The amendment revises the Technical Specifications to change the burnup dependent total peaking factor. Specifically, the exposure range for which the total peaking factor is defined has been extended from 37 GWD/MT to 43 GWD/MT (peak rod).

KEWAUNEE NUCLEAR PLANT

Amendment No. 54
License No. DPR-43

SAFETY EVALUATION BY THE OFFICE OF NUCLEAR REACTOR REGULATION
RELATED TO AMENDMENT NO. 54 TO FACILITY OPERATING LICENSE NO. DPR-43

FIGURE TS 3.10-6

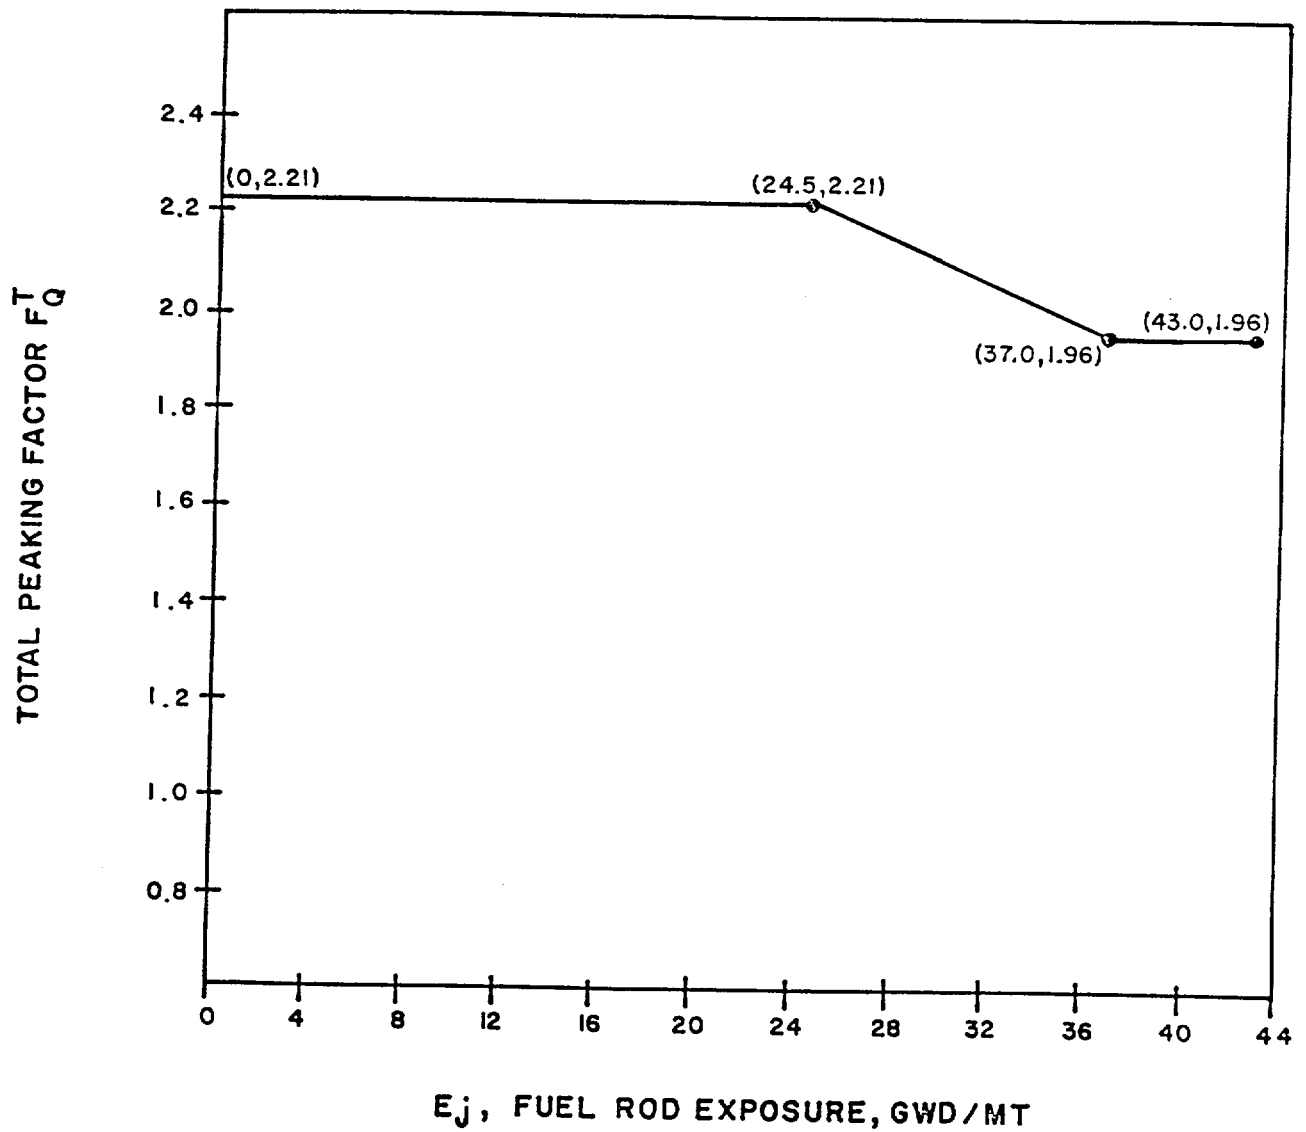
In a letter dated December 14, 1983, Wisconsin Public Service Corporation (the licensee) requested an amendment to Facility Operating License No. DPR-43 which would revise the Kewaunee Nuclear Power Plant Technical Specifications. This change extends the burnup dependent total peaking factor, Fq^T , at a constant value of 1.96 from 37 GWD/MT to 43 GWD/MT (peak rod).

The licensee has provided an analysis justifying that the LOCA ECCS calculations support extension of the exposure to 43.0 GWD/MTU, with F_q^T constant at a 1.96 value from 37.0 to 43.0 GWD/MTU. We have reviewed this analysis and find it satisfactory.
